Technical Service Bulletin

72 Rear center seat rattles and does not fold flat

72 13 08 2023324/2 September 10, 2013. Supersedes Technical Service Bulletin Group 72 number 10-01 dated April 23, 2010 for reasons listed below.

Figure 3. The release lever button and lock cover (arrows).

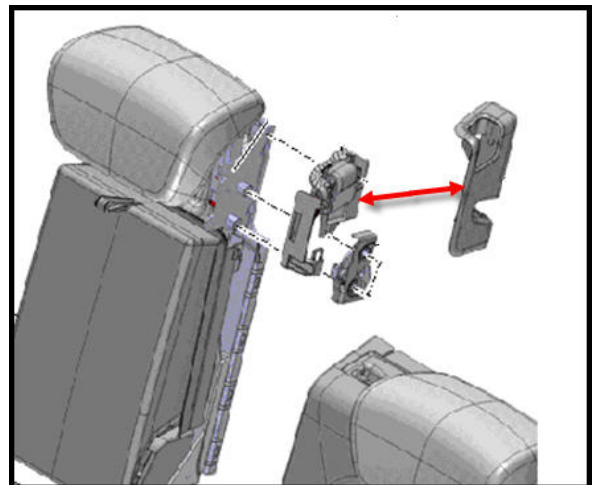
2. Use the repair instructions in Elsa to remove and replace the release lever button and the lock cover (Figure 3 and Figure 4).

Follow the instructions below to replace both the release lever and the lock cover.

Figure 4. The optimized connection point of the release lever and the connecting rod.

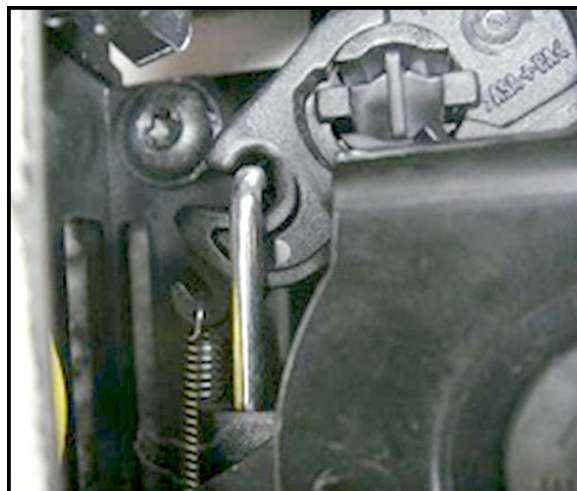
The connection between the release rod and the release lever is optimized. The release lever is optimized.
